02 - 2010
6339DWFE
14.4V 1/2" DRIVER DRILL KIT
3 - SPEED

SERVICE CHANGES

Shape of gear assy

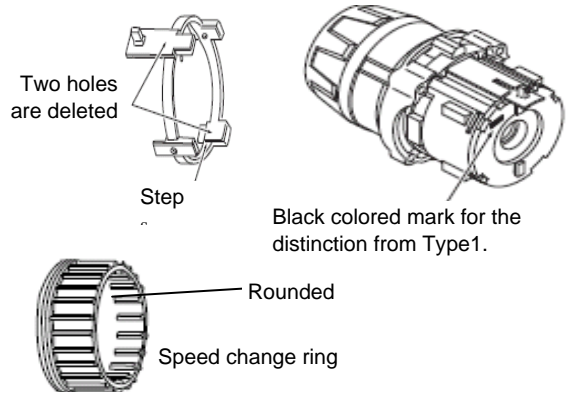
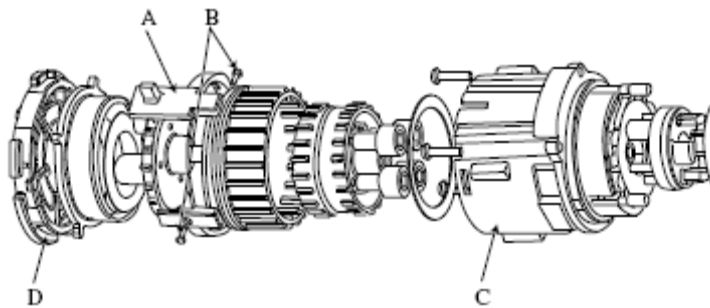
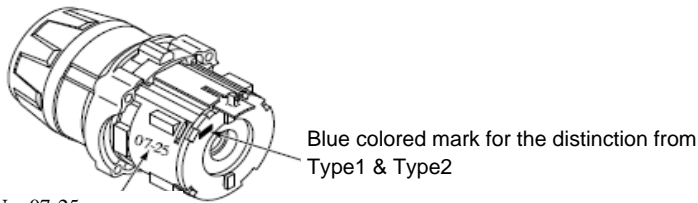
Item No.	Description	Type 1	Type 2	Type 3
15	Gear Assy	125284-0	125340-6	125432-1
Component of Item No.15	Speed Change Ring	418763-8	419558-2	
	Pin 1.2 / Pin 1.4	268088-8		268199-9
	Change Lever	-----	419557-4	450385-8
5	Speed Change Lever Assy	125261-2		125434-7

Above parts are completely interchangeable as a set.

Gear Assy Type 1 (Color of Lot No. : White)

Gear Assy Type 2 (Color of Lot No. : Silver)

Gear Assy Type 3 (Lot No. 07-25 ~)

A: Change Lever

B: Pin 1.4

C: Gear case A
D: Motor Bracket

Gear case A and Motor bracket are changed. Factory-assembled with the other components. Supplied as the new gear assy.
